Re: COGCC FIELD INSPECTION REPORT [Doc#714002070, Loc Id: 333602 Name: OLSON-SMITH UNIT-N33N8W 8SESE] SUBMITTED NOTICE

COGCC Field Inspection Report

Photo 4. Gas line riser that remains in the northwest corner of the pi

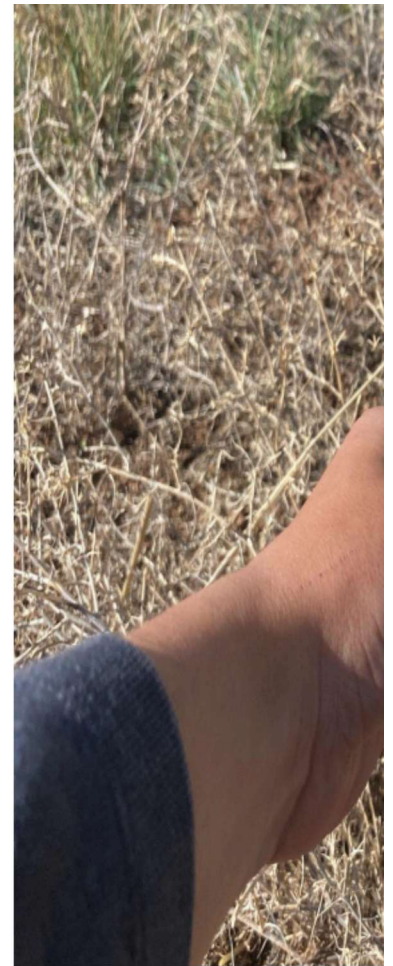
| Inspection doc #714000107 observed risers in the western edge of the project area and required compliance by 8/19/2029. It was observed in this inspection that a gas line riser remains on location. Original CA has not been addressed. Original CA and date remains applicable. No CA date is being provided as this location is out of compliance for the same Rule. | |
| Comply with Rule 1004.a to remove (regardless of ownership) all debris, abandoned , gathering line risers, flowline risers, and equipment within three months of plugging (5/9/2017) the associated facility. | |

The riser is active as it is part of a pipeline from the well pad to the north. See image below and the original photo annotated to show the wells that are associated with the riser.

Sorry for the delayed response. I was able to speak with my team lead and where the gathering line is active, the riser is not and is associated with the plugged and abandoned well. All surface equipment would require removal, or a final reclamation variance would need to be submitted to leave any risers on the location.

We can ask for a variance but I disagree with your application of the rule because the riser is not abandoned, which is what the rule states (see highlighted below from rules and from your initial FIR).

The mentioned gathering line riser is active (not abandoned) because it provides gathering for wells nearby and therefore cannot be removed at this time.
